We thank the reviewers for their insightful comments and suggestions. The original general comments are below in black, our responses follow in blue, and the revised manuscript text in red.

Referee #1:

Figure 8 – Comparison of ambient observations from the three HCHO monitors assessed in this work. (a) Pico and G2307 observations taken at SDK in 2022 and 2023, (b) Pico and Ultra with 2022 measurements taken at GT in 2022 and SDK in 2023 (c) Ultra and G2307 observations at SDK 2023.

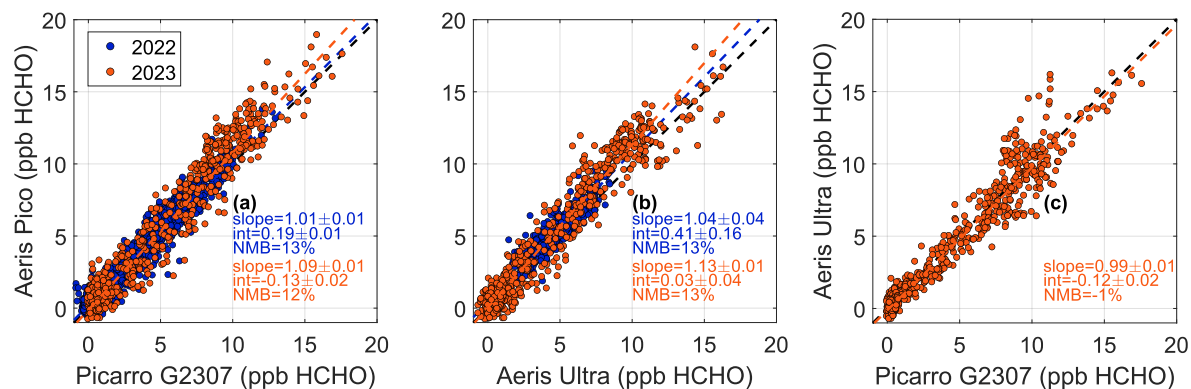
- 2) The Aeris instruments either weren't calibrated (Ultra) or were post-corrected based on comparison with the Picarro (Pico). Therefore, the slope and intercept in Figure 7 are essentially a test of how good the Aeris calibration is. Given the 15+ months from manufacturing to use, the strong comparison is impressive but perhaps not very useful.

To address this concern, we've performed a dynamic dilution calibration as well as a second round of standard addition calibrations for both Aeris units, discussed in Sect. 2.2.5 (above). The results indicate negligible change in their sensitivities throughout deployment.

We have also performed a second round of intercomparisons with all three instruments co-located, now shown in Sect. 4.2.1. (above). We found that after applying various calibrations that all instruments agreed within 13% of each other. Calibrations are discussed in sections 2.1.6 and 2.2.5.

Figure 2 – Picarro G2307 baselines determined using the DR, DR+MS, or DNPH scrubbing methods. Each data point represents a consecutive, 4.5-min averaged DNPH and DR baseline measurement.

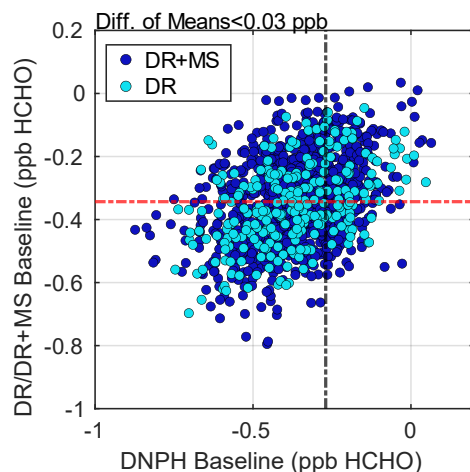
- 6) This should also be considered when discussing the ~0.5 ppbv offset difference between the DR / DR+MS baseline and the DNPH baseline for the Picarro instrument. Although the DNPH cartridge makes sense for doing humidity-matched baseline corrections, it appears (Figure 3) that the Picarro is plumbed such that the zeros are performed from indoor air passing through the DNPH scrubber. In this configuration the instrument loses the ability to perform humidity-matched zeros, which seems to negate the major reason for using DNPH over a different scrubber (e.g., humidified zero air or just dry zero air). A zero-air cylinder would last longer than a DNPH cartridge, not have the potential concerns about acid / solvent off-gassing, and could last indefinitely with an appropriate zero air generator.

We thank the reviewer for these remarks. Our new humidity-dependent data processing scheme for the Picarro G2307 measurements has significantly altered our appraisals of DR/DR+MS and DNPH-coated cartridges. Details of the impetus for and derivation of this correction are provided in Sect. 2.1.3 of the revised manuscript, found at the beginning of this document.

Importantly, the application of this correction also removes the need to match humidities between ambient and zero measurements. After applying the humidity-correction to the data, the difference in DR/DR+MS, and DNPH-derived instrument baselines is now <30 ppt.

Furthermore, we conducted an additional experiment comparing baselines from a Tofwerk zero-air generator, and two DNPH-coated cartridges – one sampling indoors and the other outdoors. Mean relative differences of 5 min integrated baselines between the HCHO-scrubbers are within 12 %, corresponding to a mean absolute difference of 14 ppt HCHO. This is now stated in Sect. 2.1.5

Figure R1 – HCHO peak absorption at a wavelength of 1.78e-4 cm as reported by the Picarro G2307 when sampling through either a DNPH-coated cartridge or a zero-air generator. This period is binned via instrument-reported % H₂O when sampling through DNPH.

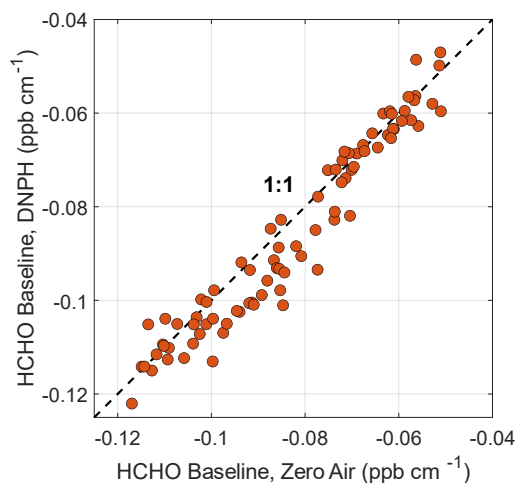
- 5) The LpDNPH S10L cartridges are made by coating silica gel with 2,4-dinitrophenylhydrazine in an acidified solvent solution. As a result, the LpDNPH S10L cartridges will emit small amounts of solvents (possibly acetonitrile or methanol), acid gases (e.g., HCl or H₂SO₄), and possibly volatilized byproducts of the DNPH reactions. It is not immediately clear what impact those might have on the cell or mirrors in the G2307, or whether any of those compounds might contribute to spectral interferences in the formaldehyde retrievals in the 5626 cm⁻¹ region.

To the point of the referee, we have added a section discussing short term effects of DNPH-cartridge offgassing on the Picarro G2307's HCHO absorption spectrum in Sect. 2.1.5.

To provide further detail, we’ve included Fig. R1 below, which shows the Picarro G2307’s instrument-reported HCHO peak absorption. A comparison of the G2307’s baseline when sampling through a DNPH-coated cartridge (following the burn-in period) or a zero-air generator reveals that absorption at the HCHO peak is effectively equivalent as regressions between the two methods have negligible intercepts and a slope of 1.02, leading us to conclude that there are no short-term spectral interferences.

Figure 9 – 8 h TO-11A DNP observations compared to Picarro G2307 observations at the SDK site from June through August 2022. Error bars represent the 10% uncertainty associated with the TO-11A and G2307 measurements.

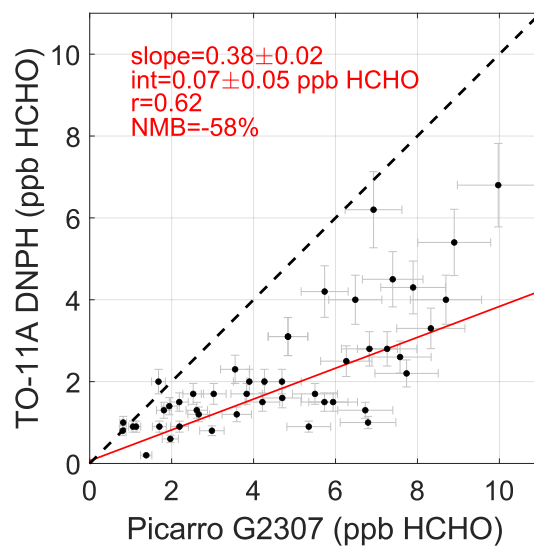
- 7) Given the large discrepancy between the Picarro G2307 and the TO-11A, there are clearly accuracy issues with one or both methods. In addition, the discrepancies observed here are larger than those observed in many other studies comparing DNPH to spectroscopic measurements.

We thank the referee for this insightful comment. To this point, there was an accuracy issue with the Picarro G2307 in that observations were not corrected for humidity. However, applying the correction exacerbates the discrepancy in question. We have provided additional analysis attempting to determine the reason for this discrepancy, discussed in Sect. 4.2.2:

Fig. 9 compares G2307 observations from June-Aug. 2022 with those from co-located TO-11A measurements. 1 min integrated G2307 concentrations are averaged to the 8 h TO-11A sampling window. We find moderate correlation ($r = 0.62$) and a -58 % NMB of TO-11A observations relative to the G2307 (slope = 0.38 ± 0.02). Previous studies have demonstrated DNPH-based observations being up to 25 % lower relative to continuous HCHO observations (Hak et al., 2005; Dunne et al., 2018). Hak et al. (2005) determined slopes in the range of 0.64-0.83 when comparing DNPH-HPLC and Hantzsch fluorometric measurements. A comparison of Hantzsch and G2307 observations in Glowania et al. (2021) produced a slope of 1.08.

While a low bias is not unusual for TO-11A measurements, the magnitude of the discrepancy presented here is larger than prior studies. We find 8 h G2307 observations are well correlated ($|r| > 0.7$) with temperature, RH, and O_3 , which are expected to either drive ambient HCHO or reflect its secondary chemistry. In contrast, TO-11A observations had weak correlations with these same variables, attaining a maximum r of 0.44 with O_3 and $|r| \leq 0.20$ for all others. TO-11A observations did not correlate notably with NO_2 which would be expected to bias reported HCHO concentrations high (Herrington and Hays, 2012). Noted in Sect. 2.1.5, summertime in Atlanta exhibits high RH and temperatures, which can lead DNP measurements to underestimate ambient HCHO by 35-80% (Ho et al., 2014). While we are unable to provide a definite reason for this significant discrepancy, the accuracy and stability shown through the G2307's calibrations as well as its agreement with the Aeris units (with independently verified accuracies) lend confidence to its measurements.

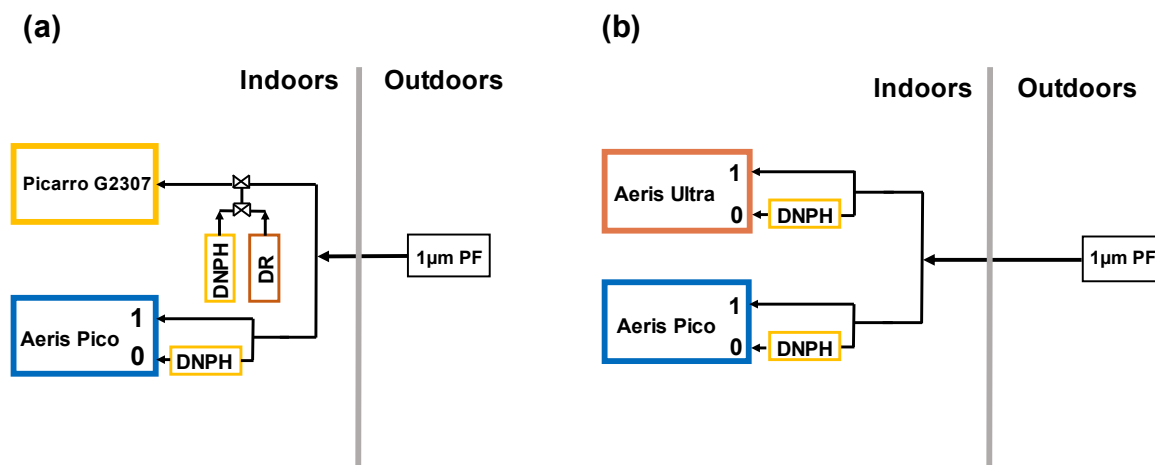
Line 178 / 179: Figure 2 is a map. I believe the authors intend to refer to Fig 3a / Fig 3b in these lines. Figures should also, in general, be added to the manuscript in the order they are referred to in the text, which would make Fig 3 the first figure (Fig 1).

We thank the author for catching this discrepancy. This figure is now Fig. 7 in Sect. 4.1.1. and all references in the manuscript have been updated accordingly.

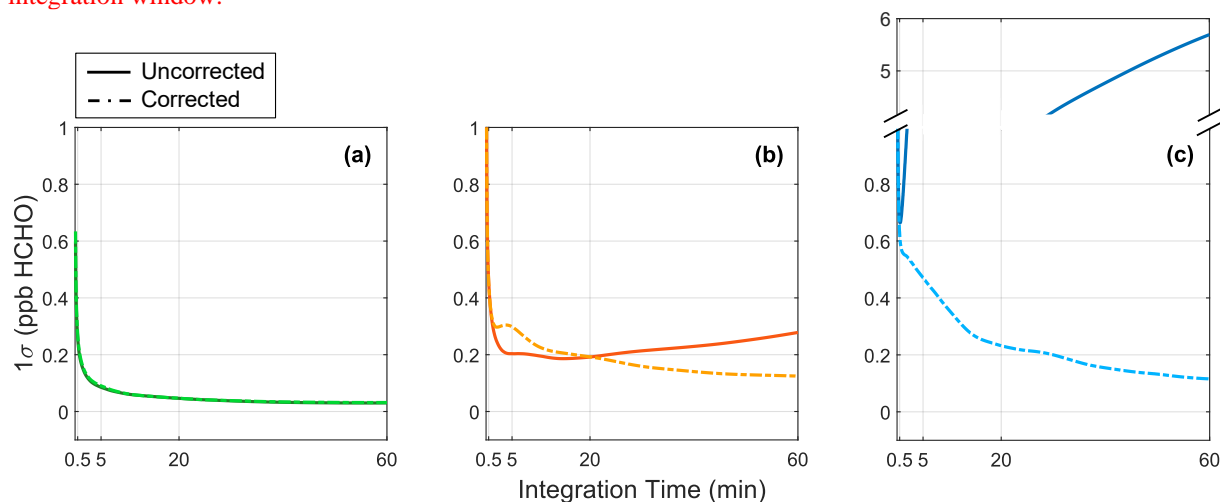
I don't trust how this figure was derived since the whole purpose of an Allen-Werle curve is to help identify the integration time at which instrument drift becomes an issue. By correcting out instrument drift beforehand, the resultant Allen-Werle curve of course looks better, but it tells the reader nothing about the instrument's precision and long-term variability. Also, when I look at the large multi-ppbv changes in variability in Fig 5 for both the Ultra and Pico, I don't see how that corresponds to <100 pptv 1-sigma precisions for 20 min integration times and higher as indicated by Fig 4.

- 7) To help address this concern, the authors should derive Allen-Werle curves using *unaltered and uncorrected* HCHO mixing ratio data as reported directly from the instruments. Reporting this gives a better indication of instrument precision and provides better comparison back to what was reported in prior work. Based on my previous comment, I'm still left wondering whether this drift correction is generalizable since can it be consistently applied to ambient data when 0 ppbv HCHO air isn't being flowed into the instruments?

Per the referee's suggestion, we have followed through with determining unmodified Allan-Werle curves for each monitor. This is described in Sect. 3 (referenced in comment (1)).

Figure 5 – Instrument baseline time series for all three HCHO monitors plotted differentially to the first point in the time series. The Ultra and G2307, equipped with better thermal stabilization, show significantly less drift than the Pico.

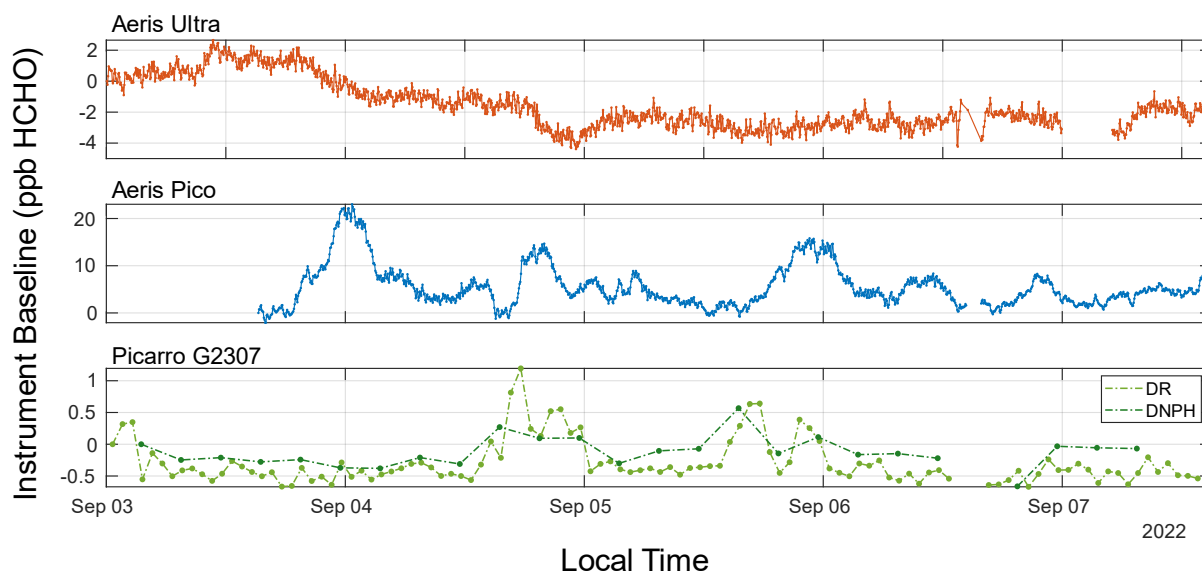
- Fig 5: Not sure what is going on during the evening of September 6 between all three instruments, but if some part of the sampling apparatus was changed at that time, then this data should be removed since the setup was altered.

Errant data from 6 Sep. 2022 has been removed for the three HCHO monitors. This is reflected in what is now Fig. 5 of the revised manuscript, located in Sect. 3.

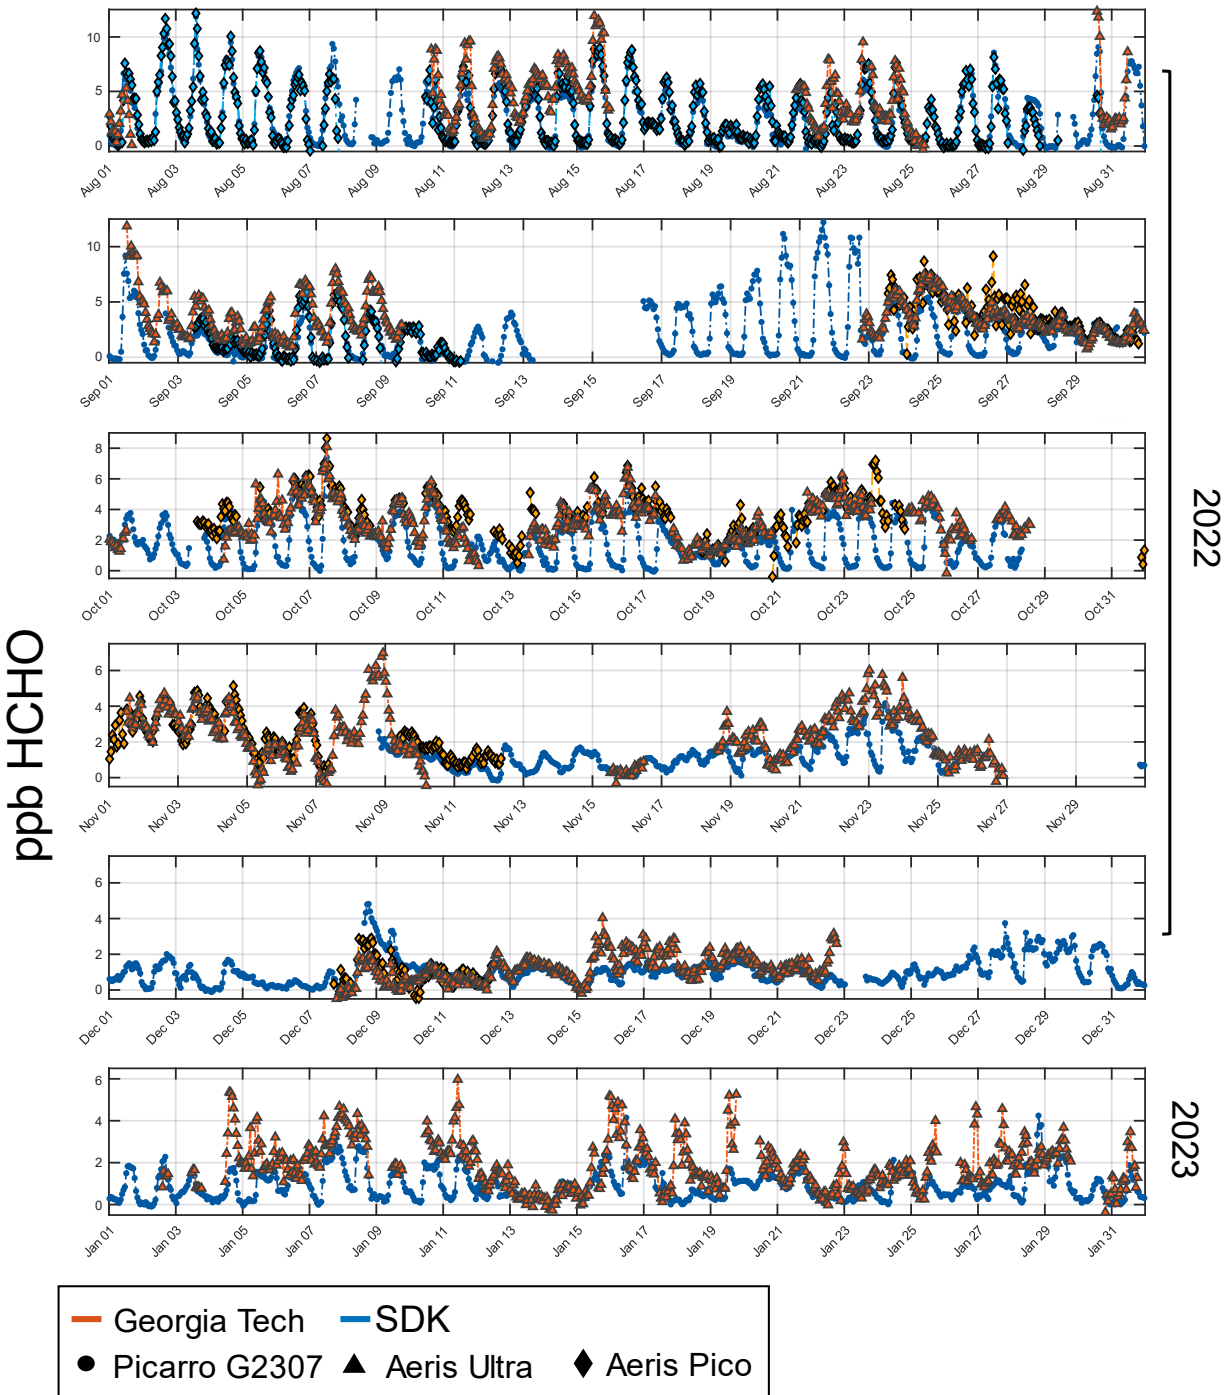
- Fig 9: It was hard for me to see when and where the Pico was sampling. Also, please make this a vector graphic since it becomes blurry and hard to read when rasterized.

Fig. 10 (previously Fig. 9) has been converted to an SVG format with an updated color scheme and increased marker sizes to hopefully improve clarity. We thank the reviewer for the suggested improvement.
